SUBJECT: CHANGES IN MANAGEMENT ORGANIZATION

Re: R. E. Ginna Nuclear Power Plant

Amendment No. 63
License No. DPR-18

SAFETY EVALUATION BY THE OFFICE OF NUCLEAR REACTOR REGULATION

Figure 6.2-1

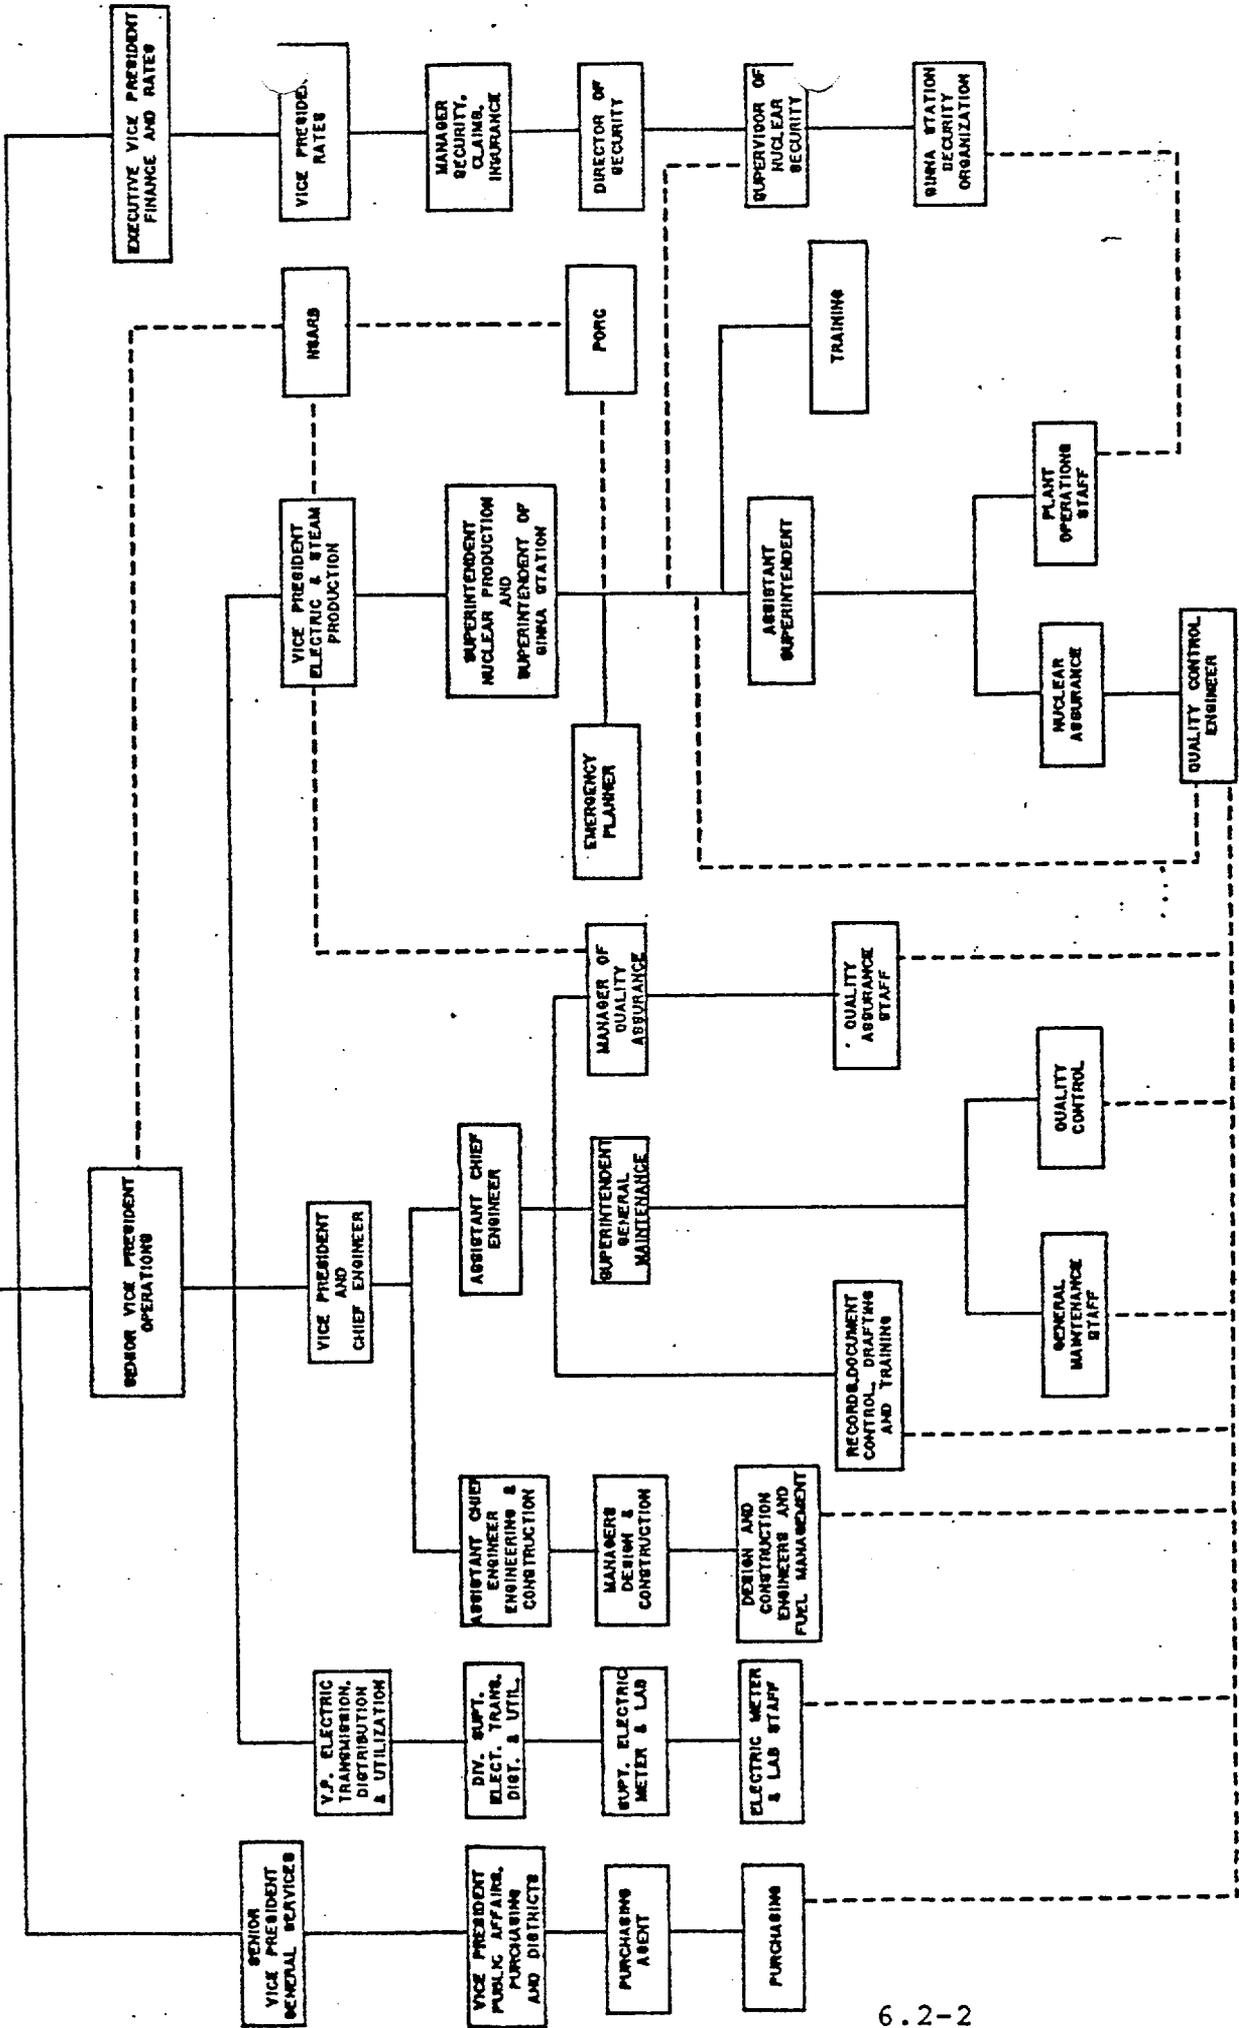
The amendment approves Technical Specification changes which:
(1) consolidate the positions of Superintendent of Nuclear Production and Superintendent of Ginna; and (2) recognize certain organizational title changes within the Rochester Gas and Electric Corporation, Inc. organization.

This amendment modifies the Technical Specifications to incorporate two separate requests by Rochester Gas and Electric Corporation (RG&E, the licensee). It also makes a minor change in the organization chart to reflect a previously requested change which was reviewed and approved by the staff but was inadvertently omitted when Amendment No. 58 was issued.

The result of the consolidation is the addition of responsibilities for corporate emergency planning to the current responsibilities of the Ginna Superintendent. The licensee estimates that these new responsibilities will require only a small amount of the Superintendent's time (5% to 8%) and the licensee states that the consolidation of responsibilities will not reduce management attention to the safe operation of Ginna.

The changes reflect changes in the RG&E management which took effect on February 1, 1984. No changes in organizational structure, lines of authority, or level of management attention to the safe operation of Ginna were made. Minor changes in title were made; the position of Executive Vice President became Senior Vice President, Operations; the position of Senior Vice President, Finance and Rates became Executive Vice President, Finance and Rates; and the position of Vice President, Purchasing and Public Affairs became Vice President, Public Affairs, Purchasing and Districts.

The NRC staff agrees that this change will not affect management attention to the safe operation of the plant. The staff also notes the added benefit that this management change results in the Superintendent reporting directly to the Vice President, Electric and Steam Production instead of to another Superintendent. On this basis, the staff finds the proposed management change acceptable.

The staff concludes that the changes will not reduce management attention to the safe operation of Ginna and will not affect the health and safety of the public and are therefore acceptable.
